Access Compliance Report

Public Rights-of-Way

Intersection ID: 52613	Main Street: GRAHAM RIDGE DR	Cross Street: HERITAGE POND DR	Location: S
ADA ID: B1CC399FE967	Ramp Type: Perp	Initial Pass/Fail: Pass	Overall Compliance: No
Severity Score: 5.25			
Codes/Mitigation Info/Possible Solution		Field Measurements/Component Compliance

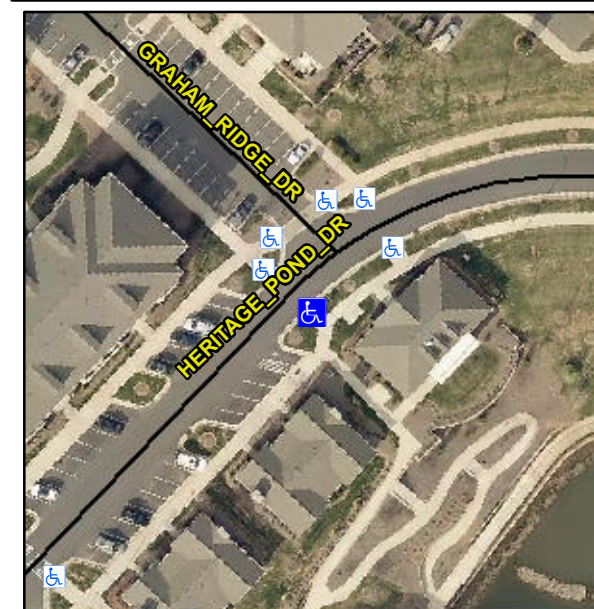
R304.5.3, R305.2, R304.5.4

Compliance	Description	Data	Compliance	Description	Data
N/A	Ramp Length (in)	97.5	Yes	Ramp Slope (%)	7.1
Yes	Ramp Width (in)	92.5	No	Ramp XSlope (%)	2.1
Yes	Flare Type L	Curbed_NoWalkSurface	Yes	Flare Type RT	N/A
Yes	Flare Slope LT (%)	N/A	N/A	Flare Slope RT (%)	N/A
N/A	Flare Traversable LT?	No	N/A	Flare Traversable RT?	No
Yes	Landing Length (in)	68.0	Yes	DWS Provided?	Yes
Yes	Landing Width (in)	109.0	Yes	DWS Contrast?	Yes
Yes	Landing Slope (%)	1.5	Yes	DWS Length (in)	24.0
Yes	Landing X Slope (%)	0.4	Yes	DWS Full Width?	Yes
N/A	Landing Curb? (Y/N)	No	No	DWS Offset (in)	4.0
N/A	Shared Landing?	No			
Yes	Gutter Ponding?	No	No	Gutter Slope (%)	5.3
Yes	Gutter Lip Ht (in)	0.0	Yes	Gutter X Slope (%)	1.1
N/A	Painted X Walk1?	No	N/A	Painted X Walk2?	N/A
	X Walk 1 Direction	To NW		X Walk 2 Direction	N/A
N/A	X Walk 1 Width (in)	N/A	N/A	X Walk 2 Width (in)	N/A
	X Walk 1 Slope (%)	4.0		X Walk 2 Slope (%)	N/A
	X Walk 1 X Slope (%)	1.3		X Walk 2 X Slope (%)	N/A

N/A	Ramp inside XWalk1?	N/A	N/A	Ramp inside XWalk2?	N/A
	Road Slope (%)	N/A	N/A	Clear Space?	Yes
	Road X Slope (%)	N/A	N/A	Clear Space to XWalk (in)	N/A
Yes	Any Obstructions?	No	Yes	Storm Grate/Utility Hazard?	No
	Obstruction Type			Storm Grate/Utility Type	
		N/A			N/A
			Yes	Surface Condition? (G/P)	Good

**Remove & Replace Entire Ramp.
Remove & Replace Gutter.**
